THE NATIONAL CONSTRUCTION CODE
VOLUME ONE

DESIGN DEVELOPMENT REPORT

TOTAL ASSET MANAGEMENT FACILITY
NEPEAN HOSPITAL STAGE 2

Revision 2

Figure No. 3 – Location of TAM facility in relation to existing multi storey car park to the east

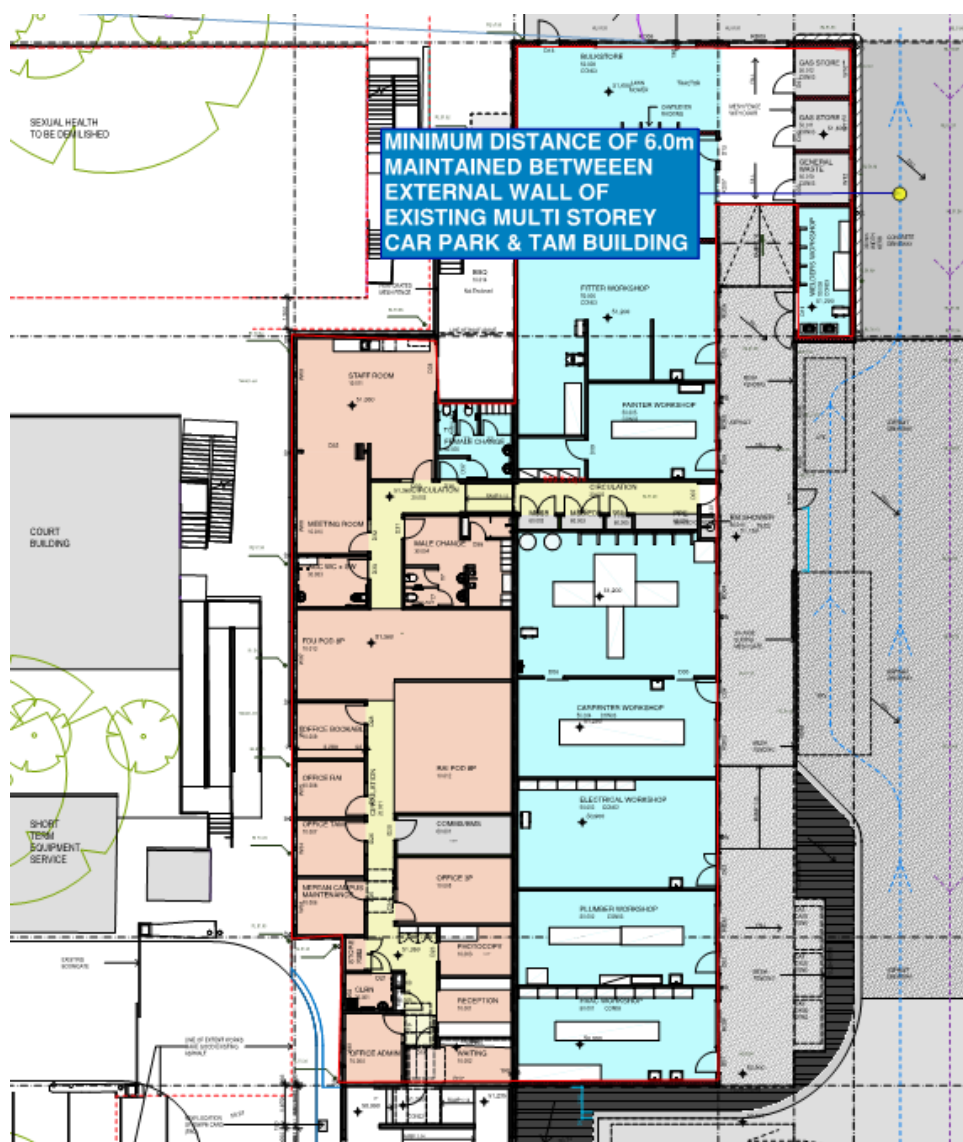
From the 'For Comment' Architectural Drawings reviewed, it appears that the TAM facility has been designed to be located a minimum distance of 6m from the external wall of the existing Multi Storey Car Park.

Figure No. 4 – Location of TAM facility in relation to the proposed CAMHS Building

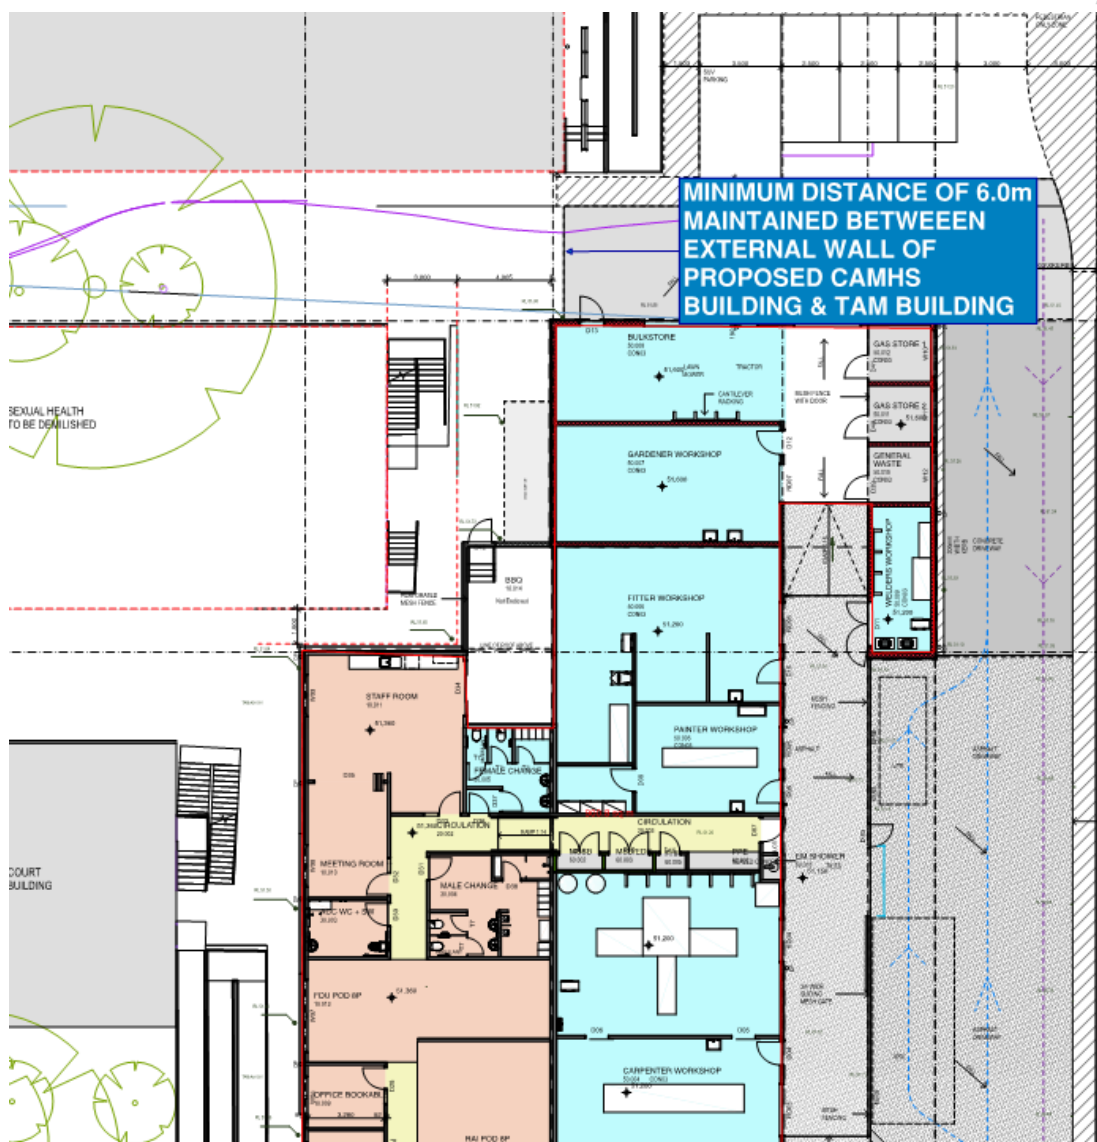
From the 'For Comment' Architectural Drawings reviewed, appears that the TAM facility has been designed to be located a minimum distance of 6m from the external wall of the proposed CAMHS Building.

Figure No. 5 – Required exit doors from the building

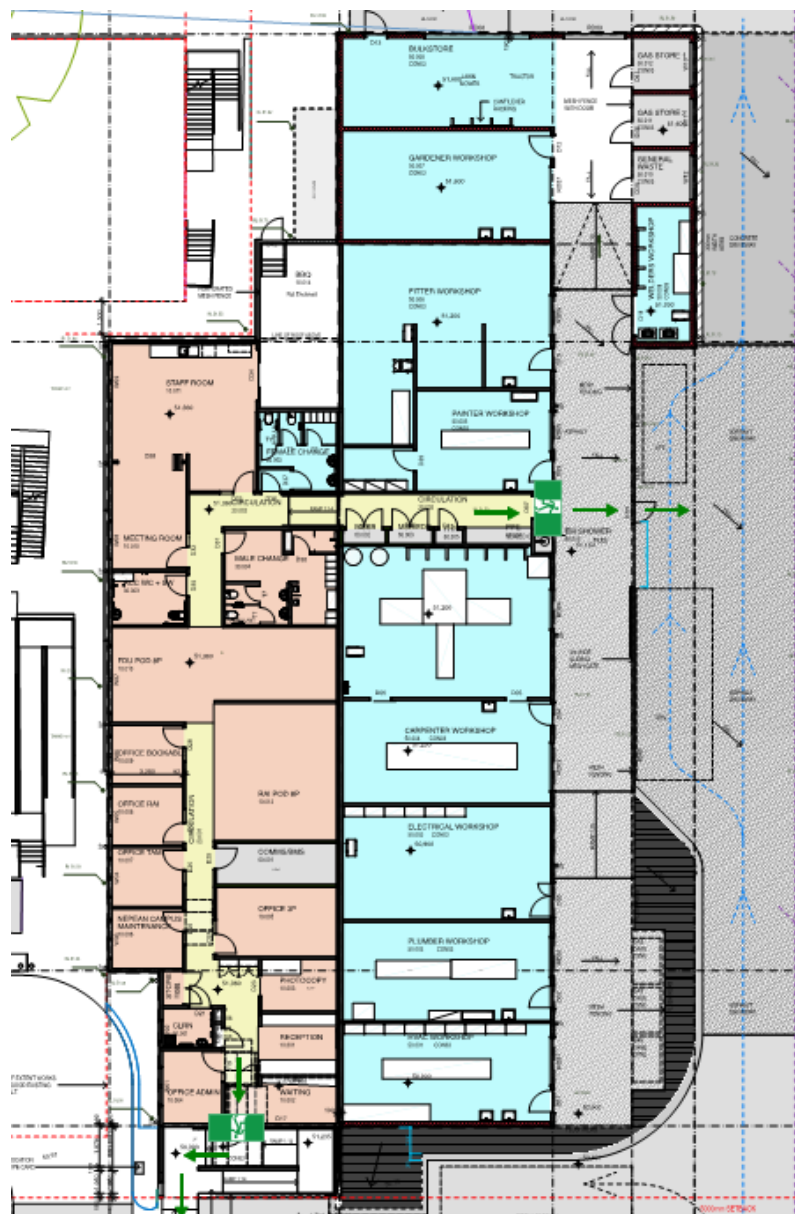
Based on the 'For Comment' Architectural Drawings assessed to date, egress travel distance to a point of choice and to an alternative exit complies with the DtS Provisions of the BCA.

The figure below details the required exit doors that have been relied upon from the building.

Note: Egress travel distance has been measured to open space beyond the roof covering above.

Figure No. 8 – Minimum landing required to stairway leading from the BBQ area

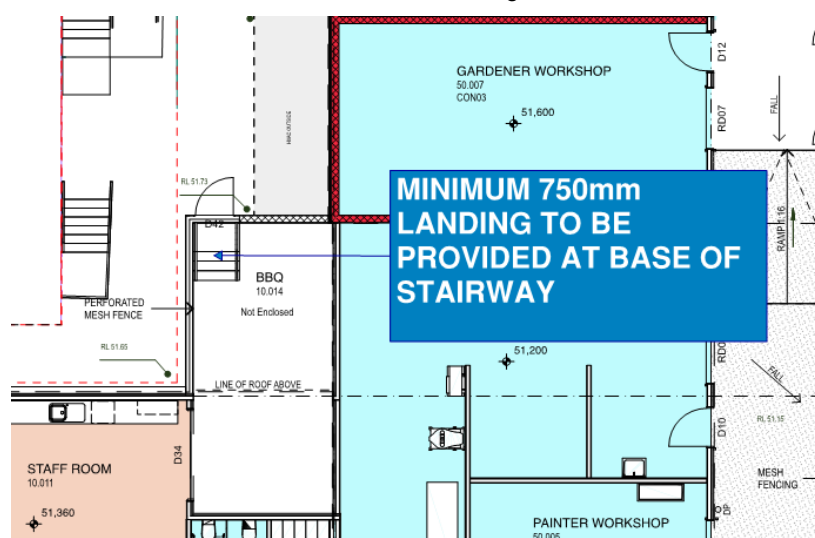
Landings are required to be provided at the top and bottom of all stairways. Landings are required to have a maximum gradient of 1:50 and be not less than 750 mm long.

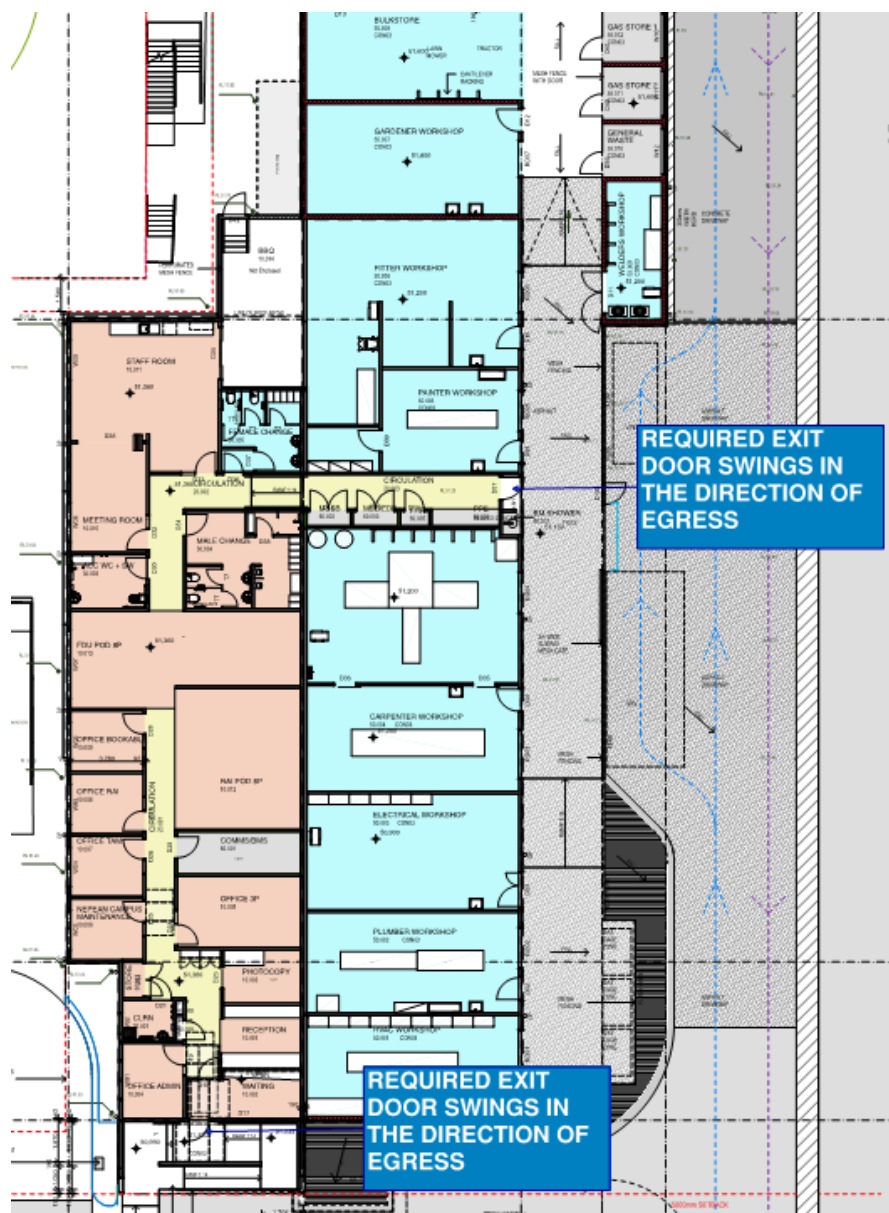
In this instance, the two nominated exit doors leading from the building are noted as swinging in the direction of egress as detailed in the figure below.

The doorways serving each of the workshop areas which lead directly to open space are not required to swing in the direction of egress on the basis they each serve a part of the building with a floor area less than 200 m², however the doorways are required to be provided with a device for holding it in the open position.

Figure No. 22 – Circulation Space required to accessible doorways

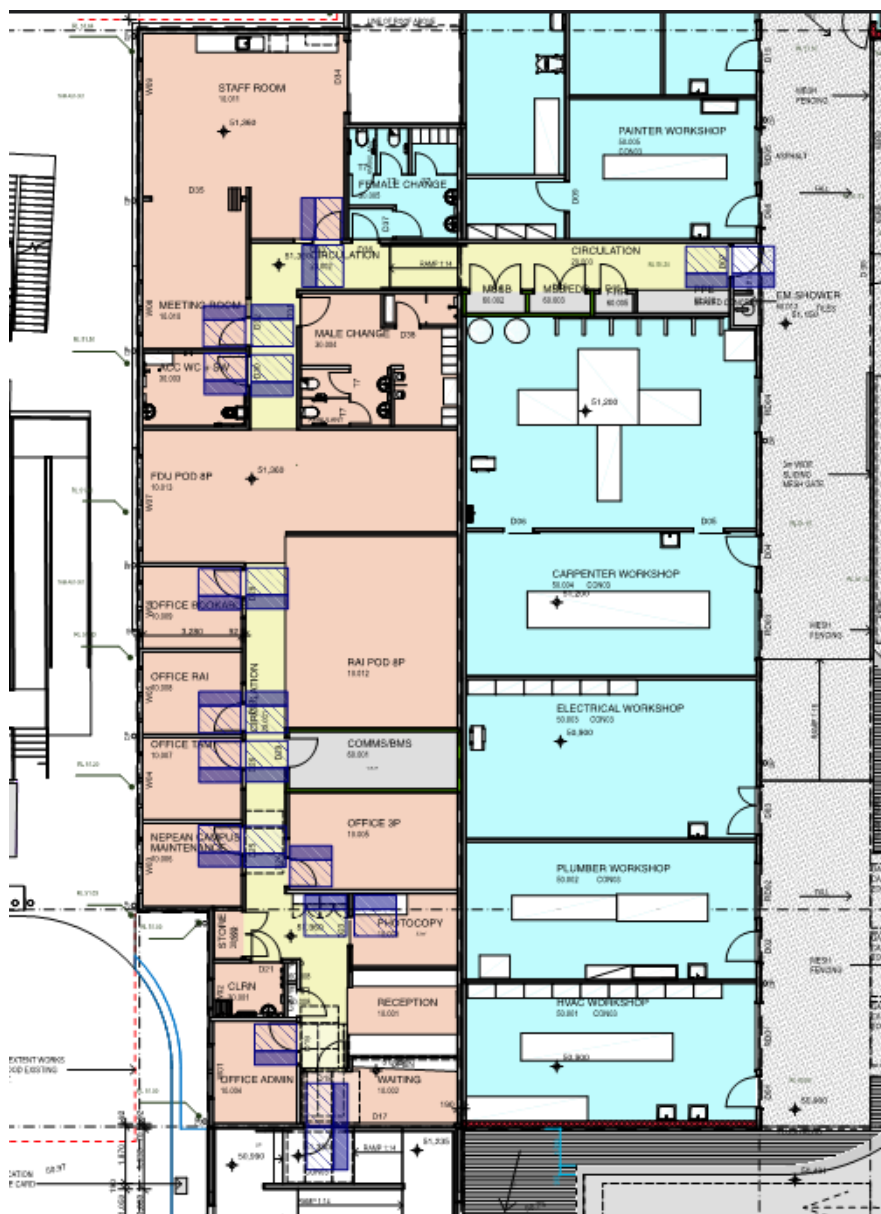
The figure below details doorways that require compliant circulation space on both sides of the doorway

Figure No. 43 – Rooms that are eligible for a Clause D3.4 concession for access for a person with a disability

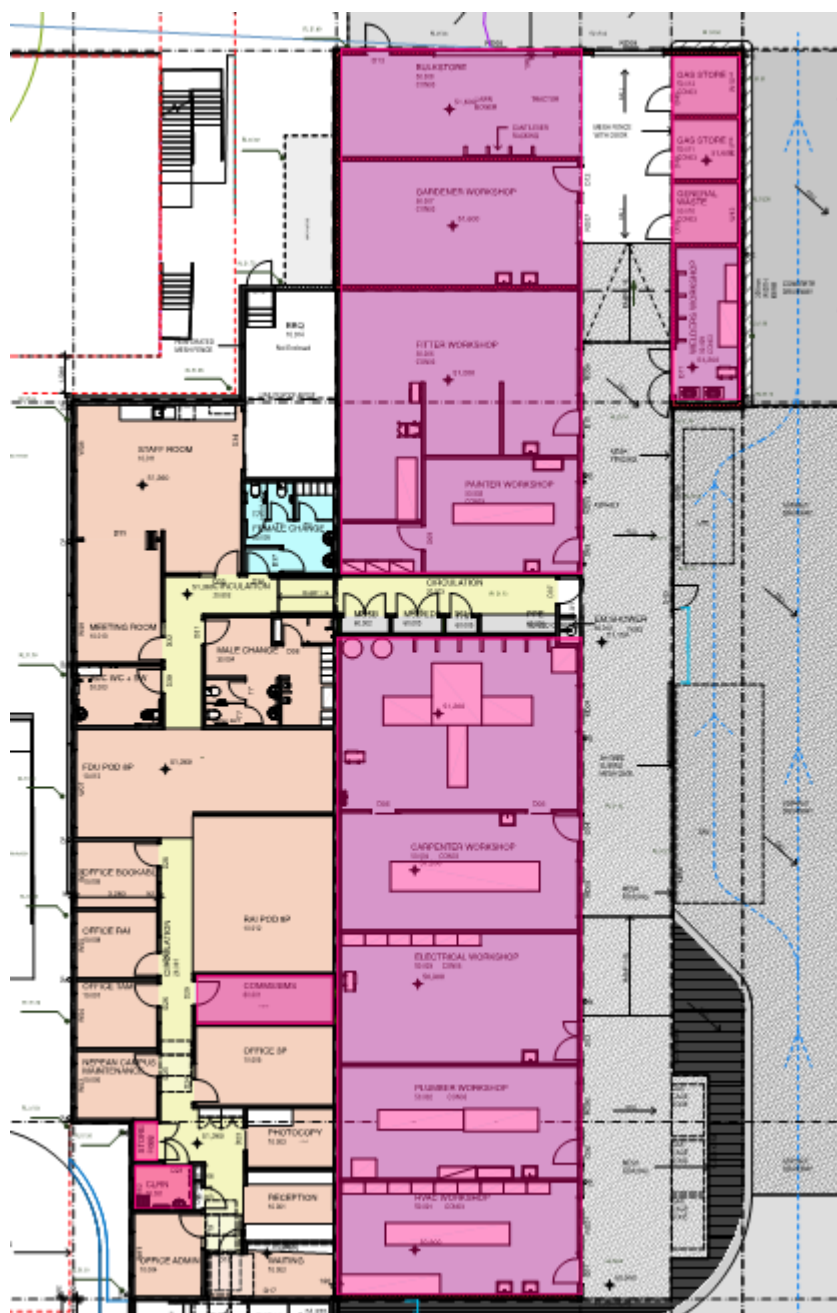
The figure below details location of rooms that may receive a concession in accordance with Clause D3.4 of the BCA.

The LHD are to provide written confirmation that access for any staff members with a disability (wheelchair bound) is not required to be provided to the abovementioned rooms.

Figure No. 45: Location of fire hose reels located within 4m of exits

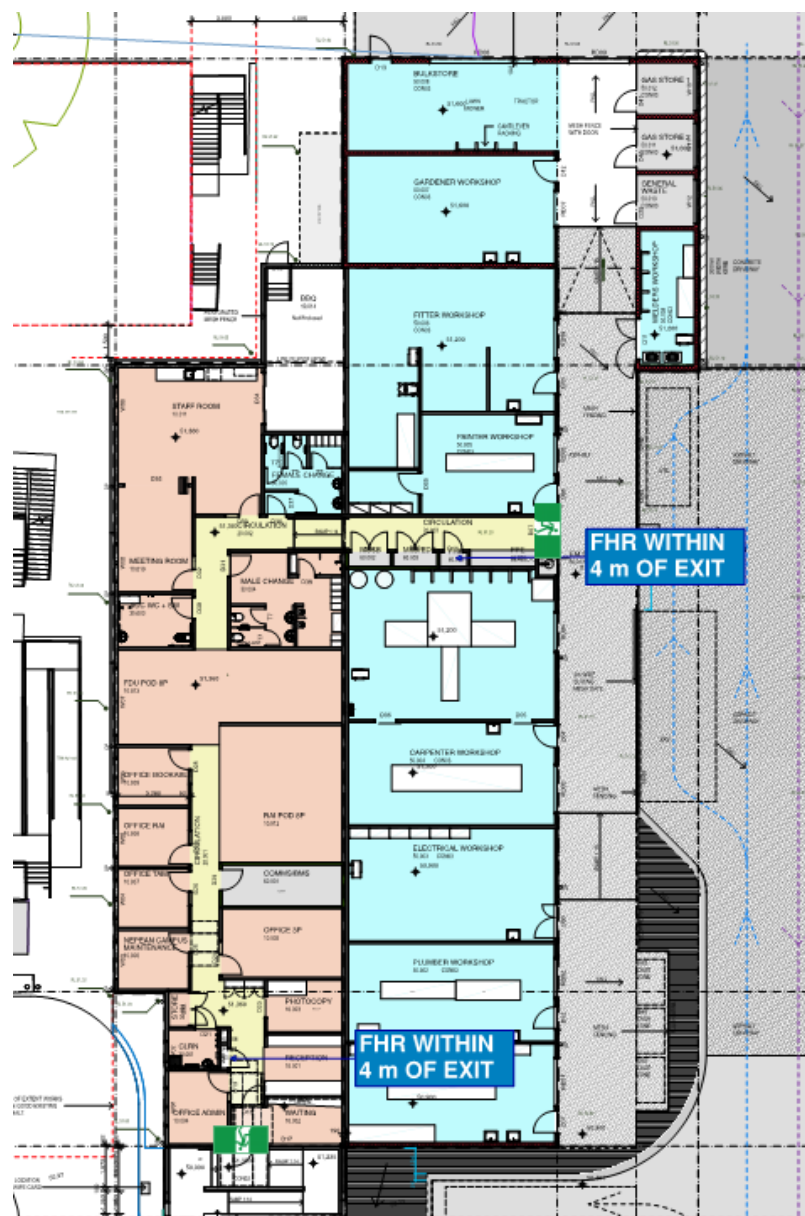
It is noted that two internal fire hose reels are positioned within 4 m of the required exit doors as indicated on the Architectural Drawings.

Figure No. 46: Cupboard doors that are required to swing 180° degrees against wall face

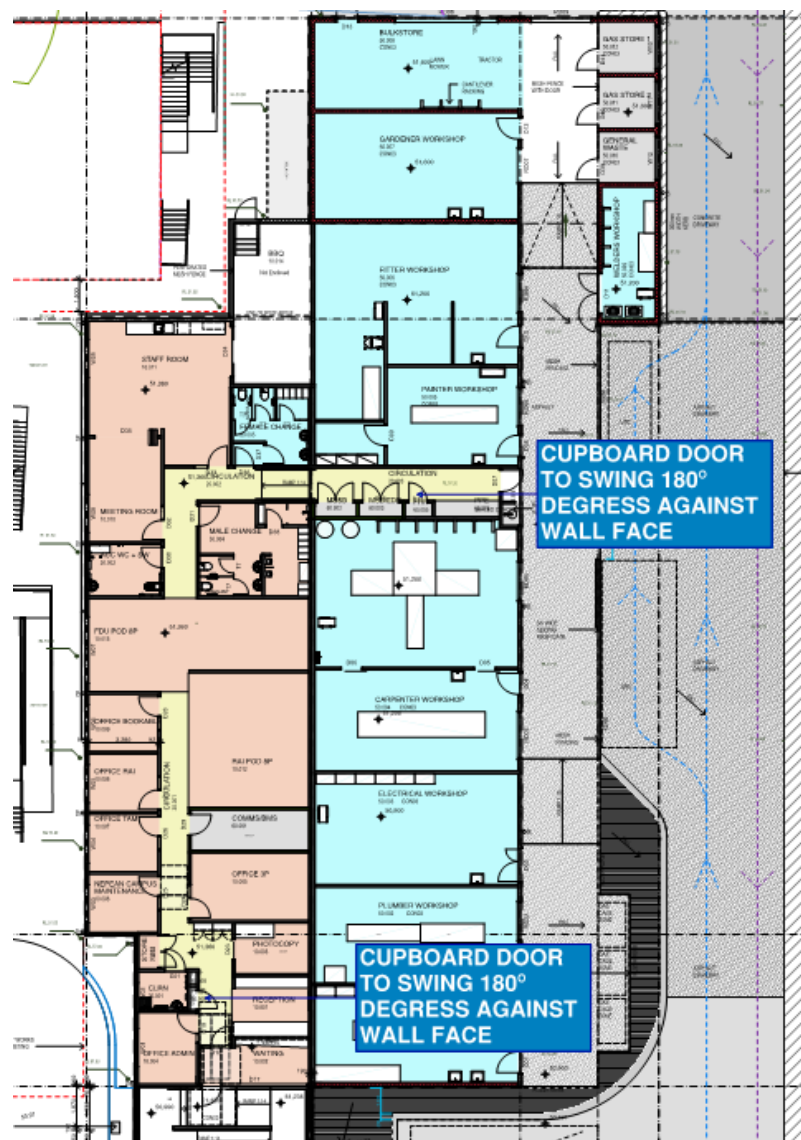
In this instance, doors to cupboards will be required to swing 180° open against the wall face or in some instances, two smaller doors may need to be provided to cupboards so as not to impede the width of exits. Special attention is required to cupboards located directly adjacent to fire safety doors throughout the building.
